**U.S. Army Corps
of Engineers**
Engineering and Support
Center, Huntsville

Gate 10 CDC (Gardner Hill) (0-5);

Building 7404 Fort Campbell, KY

**POTR – Phase 1
Project No 58583**

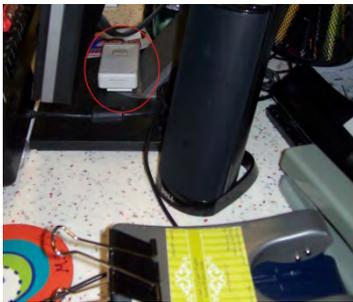
- Not enough counter space at reception desk; need space for swipe in computer, point of sale computer, 2 networked computer workstations.
- Intercom needs to have a handset at the reception counter.

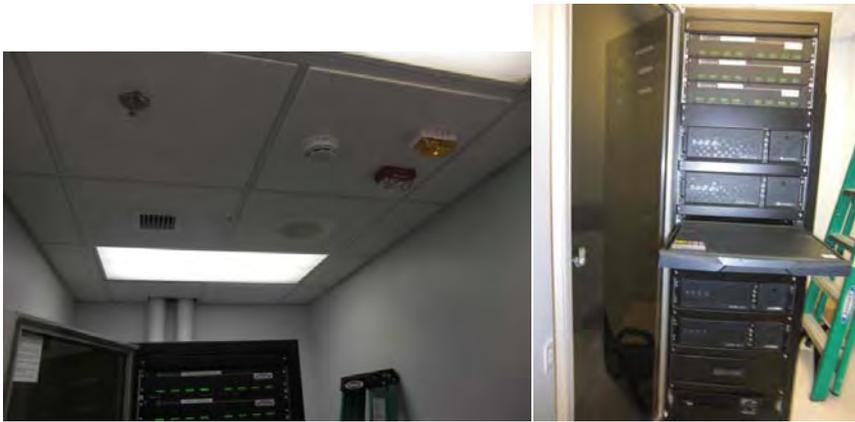
- Document satisfaction with intercom system (announcements understandable) No, The intercom is position too low on the wall.
